HISTORIC AND DESIGN REVIEW COMMISSION

HDRC CASE NO: 2019-357
ADDRESS: 831 LAMAR ST
LEGAL DESCRIPTION: NCB 1368 BLK 5 LOT 21
ZONING: R-6, H
CITY COUNCIL DIST.: 2
DISTRICT: Dignowity Hill Historic District
APPLICANT: Octavio Viramontes/HACAM PROPERTIES LLC
OWNER: Octavio Viramontes/HACAM PROPERTIES LLC
TYPE OF WORK: Construction of a 1-story, single family residential structure
APPLICATION RECEIVED: June 21, 2019
60-DAY REVIEW: August 20, 2019
CASE MANAGER: Edward Hall
REQUEST:

The applicant is requesting a Certificate of Appropriateness for approval to construct one, 1-story single-family residence on the vacant lot at 831 Lamar, located within the Dignowity Hill Historic District.

ELEVATIONS

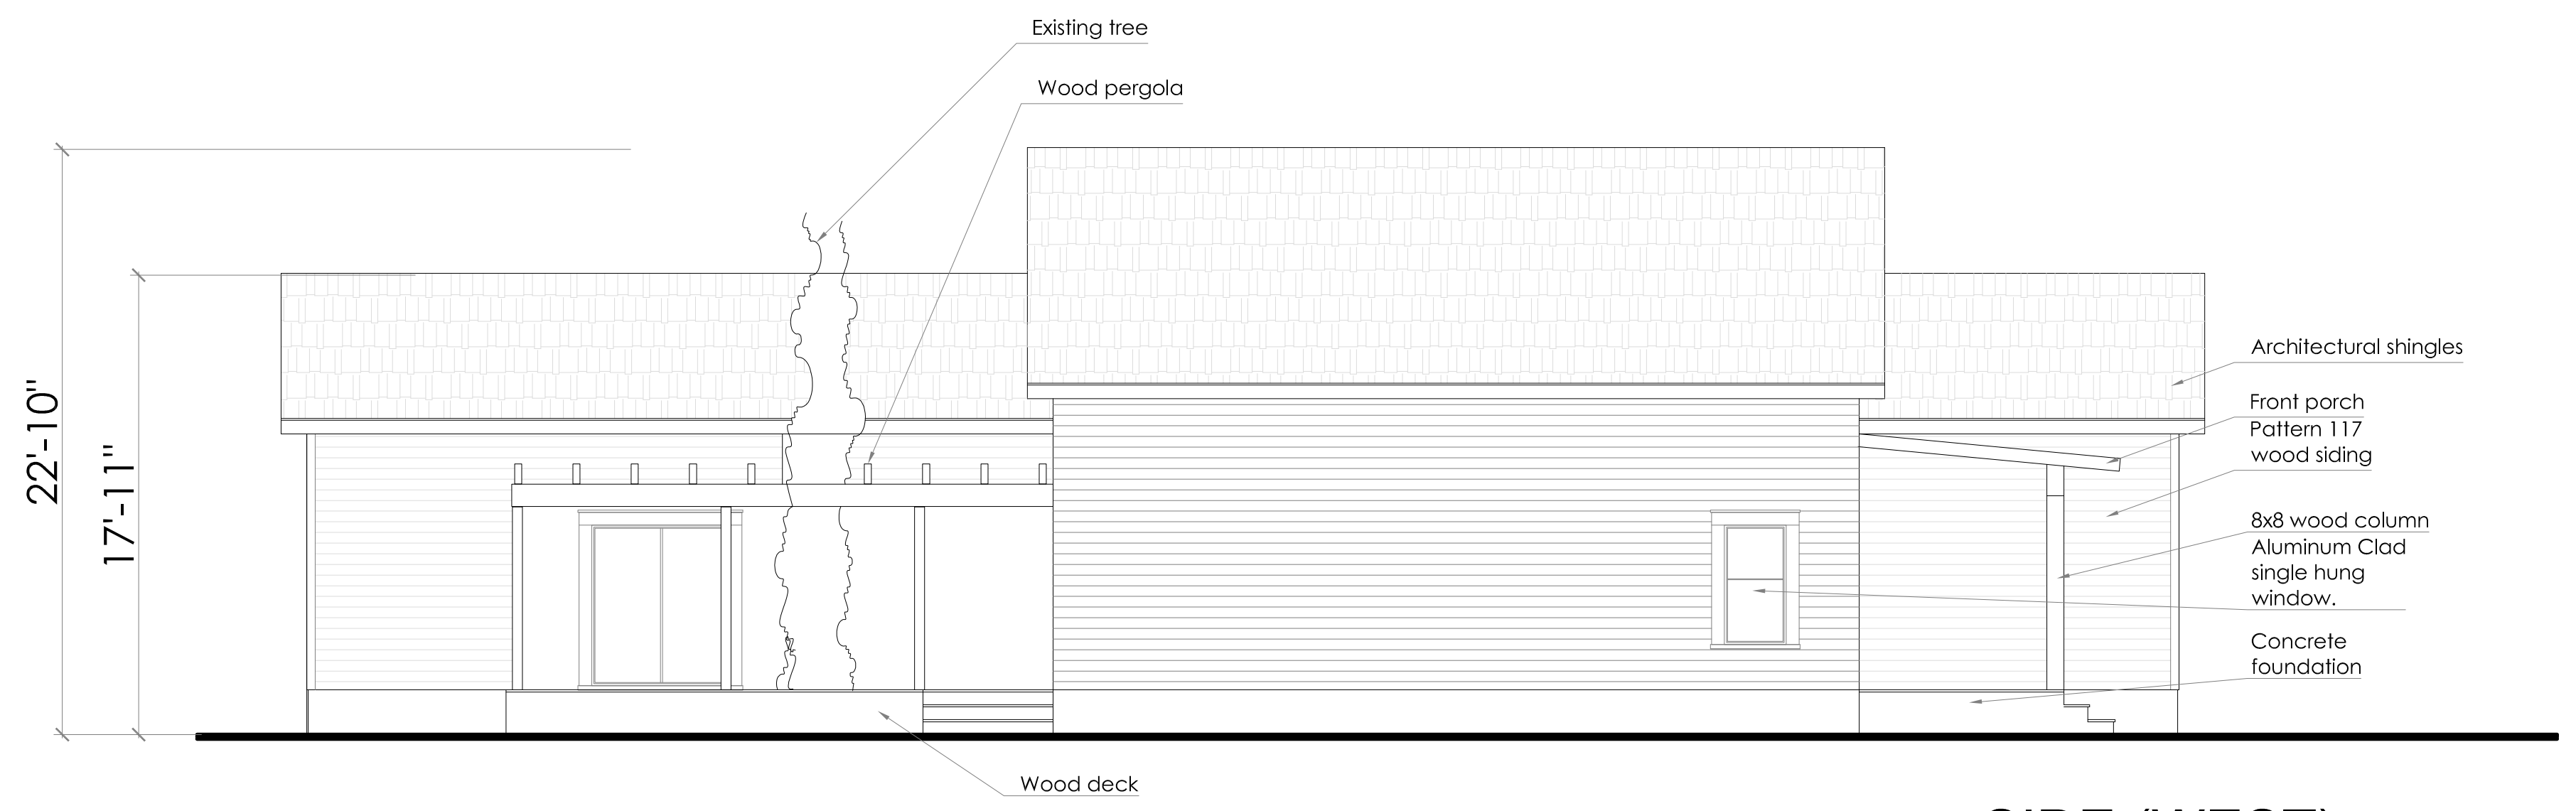
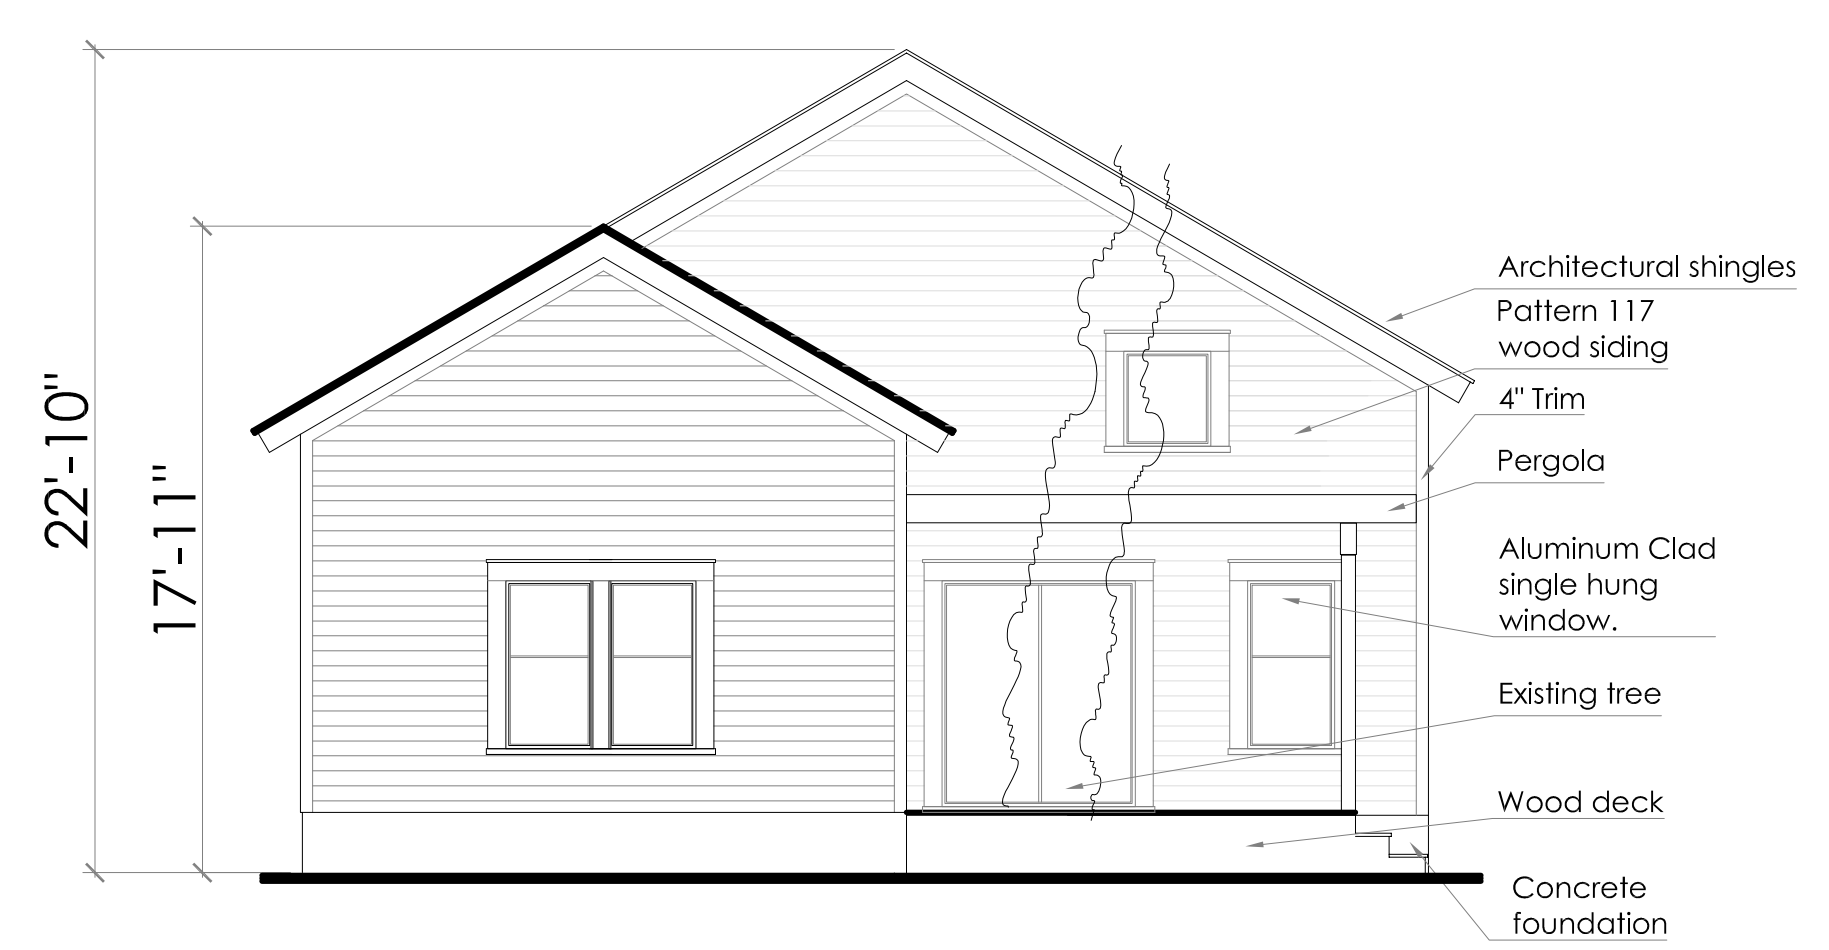
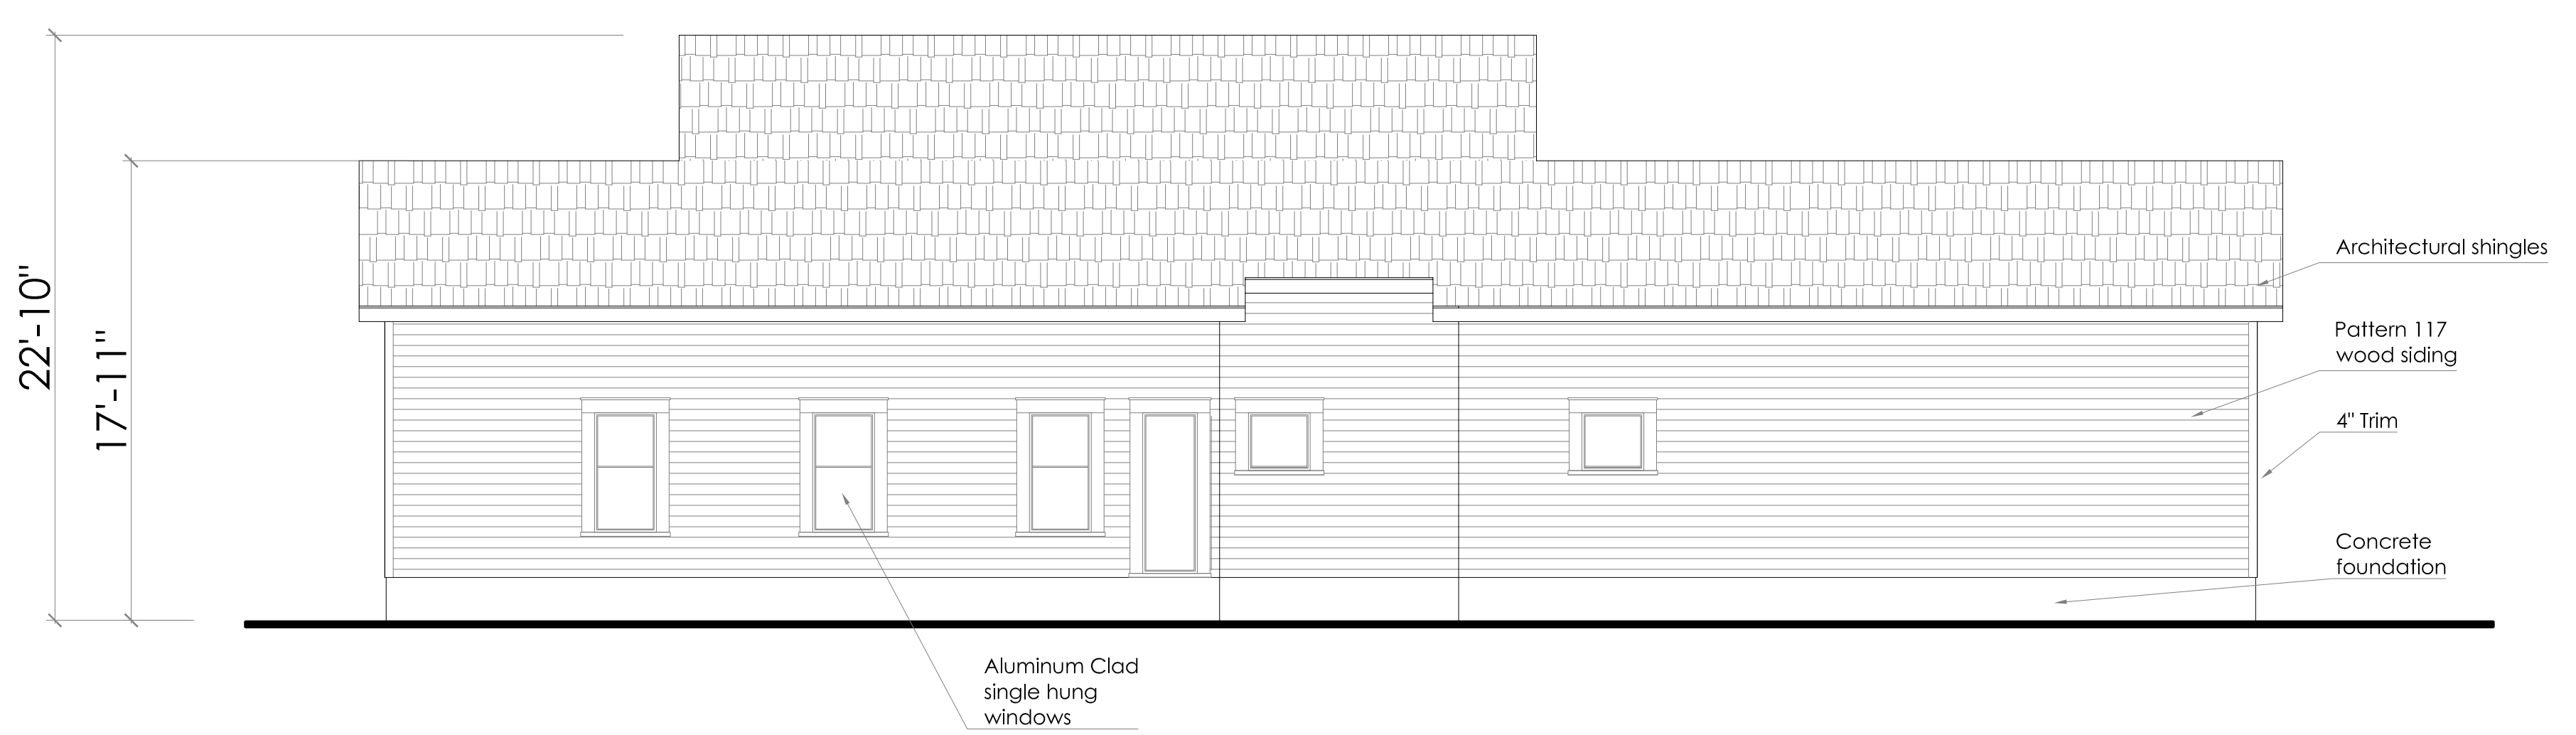
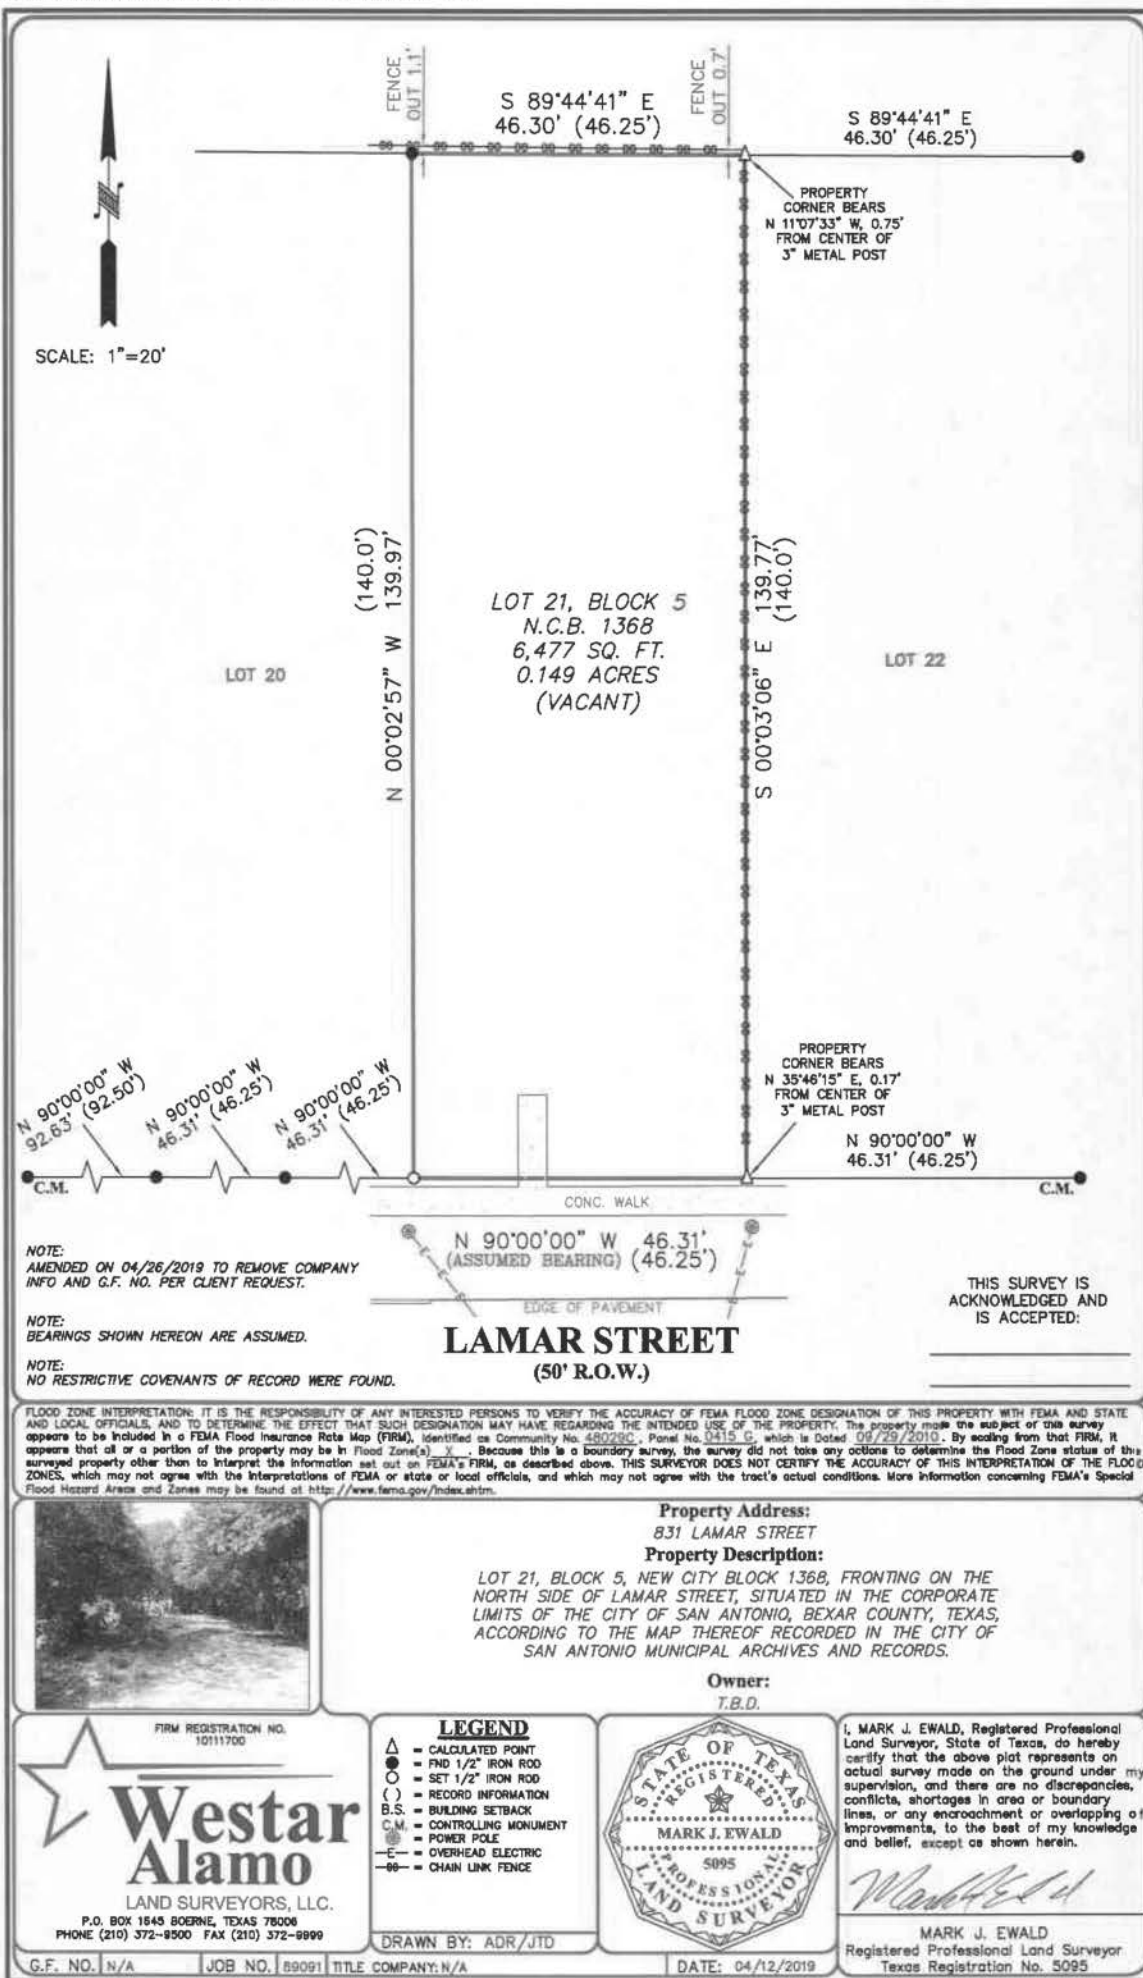
- f. **SCALE & MASS** – Per the Guidelines for New Construction 2.A.i., a height and massing similar to historic structures in the vicinity of the proposed new construction should be used. In residential districts, the height and scale of new construction should not exceed that of the majority of historic buildings by more than one-story. Staff finds that the overall height of one story, and 22' – 10" in height is appropriate and consistent with the Guidelines.

- h. **ROOF FORM** – The applicant has proposed roof forms that include front facing gabled roofs and a shed porch roof. Both of these roof forms, in this context, are found historically within the Dignowity Hill Historic District. Staff finds the proposed roof forms to be appropriate.

- i. **WINDOW AND DOOR OPENINGS** – The applicant has proposed window and door openings that generally are consistent with those found within the Dignowity Hill Historic District; however, staff finds that window proportions should be modified to include window heights that are taller. Additionally, staff finds that the applicant should ensure that all double windows are separated by a mullion that features at least six (6) inches in width.

- l. **ARCHITECTURAL DETAILS** – As noted in finding h, staff finds that the proportion of windows should be modified to feature an increased height. Additionally, staff finds that the top plate of each wall should be lowered to eliminate the excess wall height. This is combination with increasing window height will result in a proportionally accurate design.

- ii. That the applicant confirm the proposed foundation height is within one (1) foot of those found historically on the block.
- iii. That the applicant increase window heights to be more consistent with those found historically in the district as noted in finding i.

- vi. That the applicant lower the top plate of each wall to eliminate excess wall height, which will result in a proportionate façade arrangement as noted in finding l.

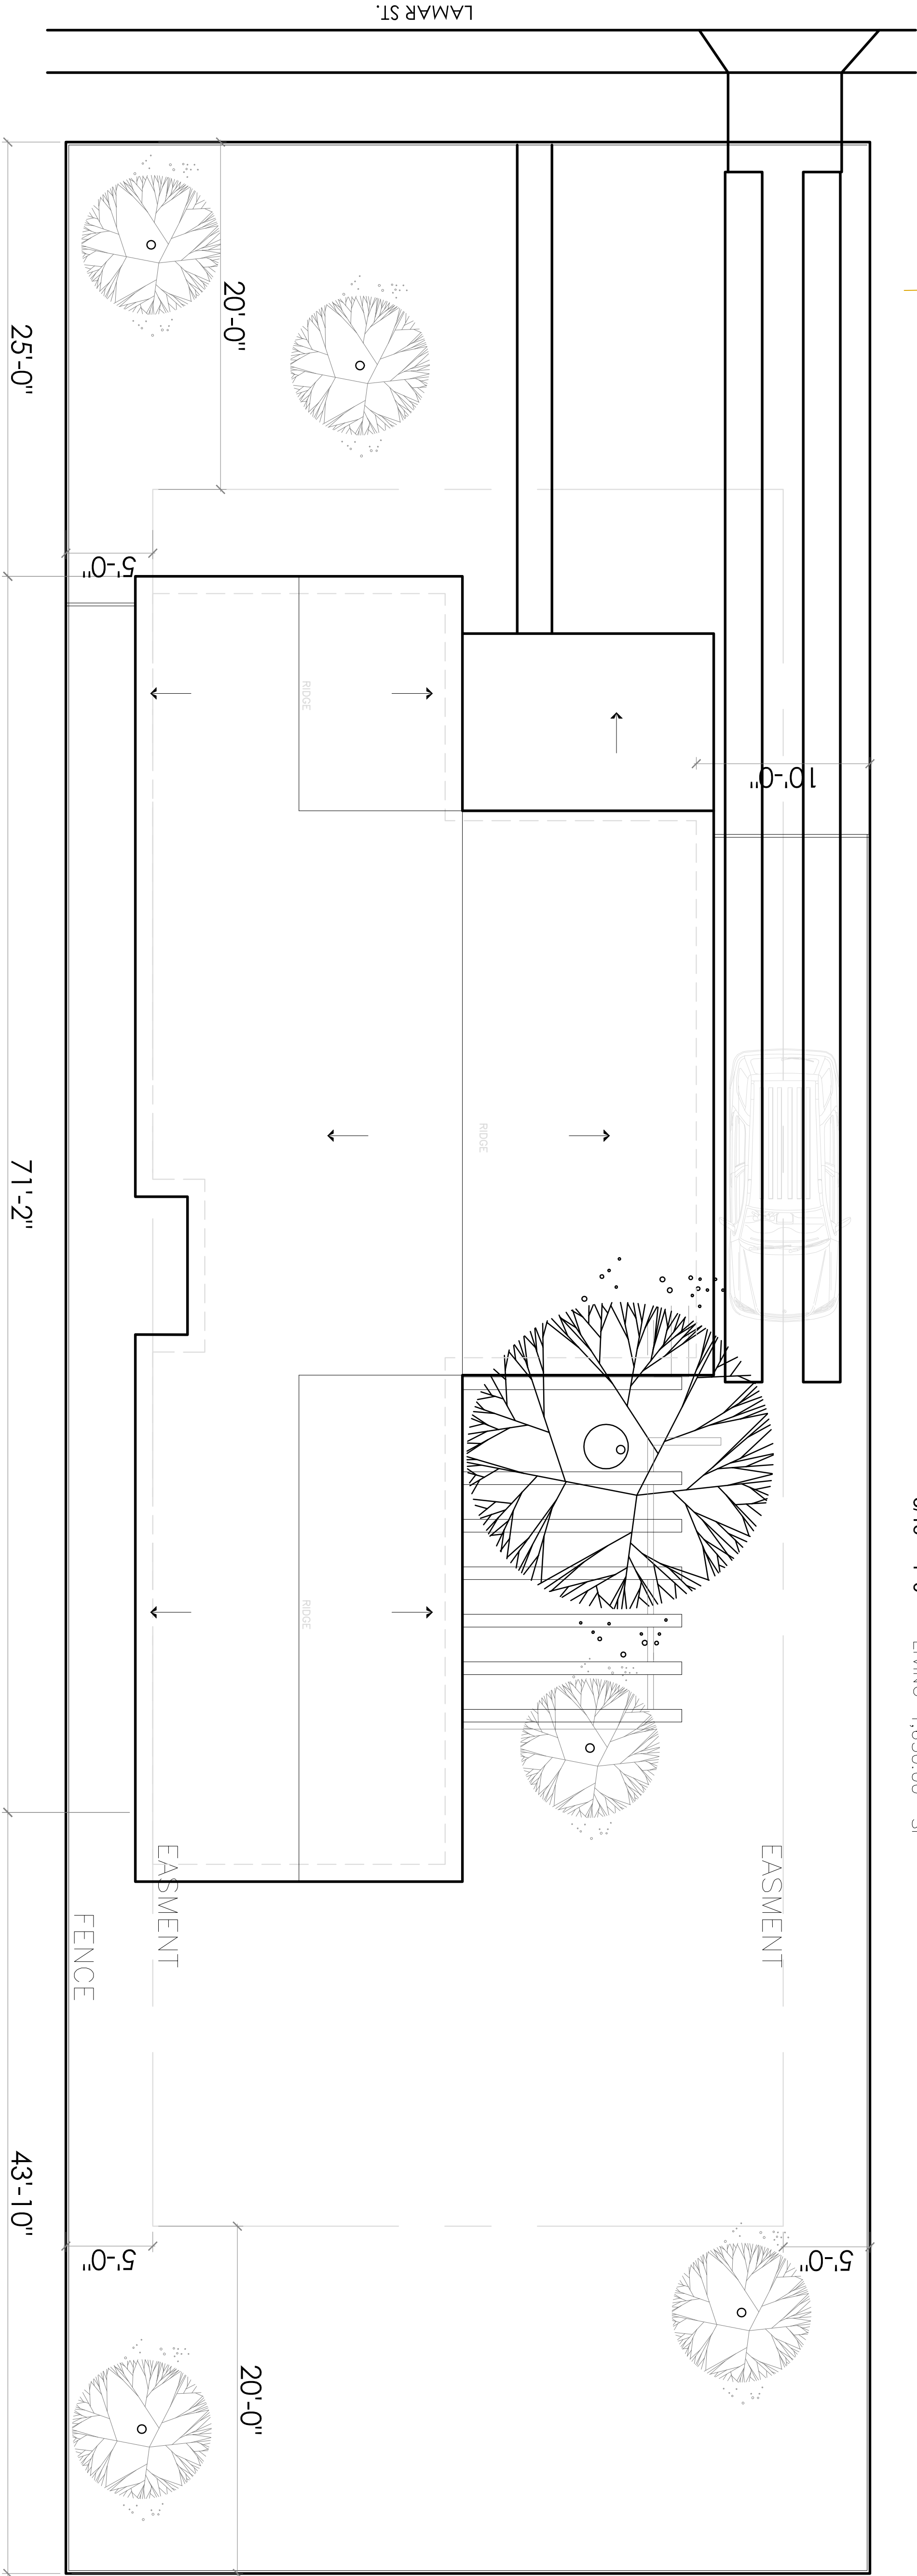
- d. **SETBACKS & ORIENTATION** – According to the Guidelines for New Construction, the front facades of new buildings are to align with front facades of adjacent buildings where a consistent setback has been established along the street frontage. Additionally, the orientation of new construction should be consistent with the historic examples found on the block. The applicant has provided a site plan noting a setback of 20' between the front bay of the house and the front property line. GIS data suggests that this setback is likely not sufficient in order to meet or exceed the setback established by the adjacent historic properties. Staff further finds that the aerial view exhibit provided by the applicant does not appear to be accurate. The applicant is responsible for verifying existing site conditions found on the block face and proposing a setback that conforms with the Historic Design Guidelines.

- i. That the applicant provide a front setback that is equal to or greater than the setback for the existing historic home located immediately to the west based on finding d. The proposed setbacks should be accurately depicted in the application materials through field verification.
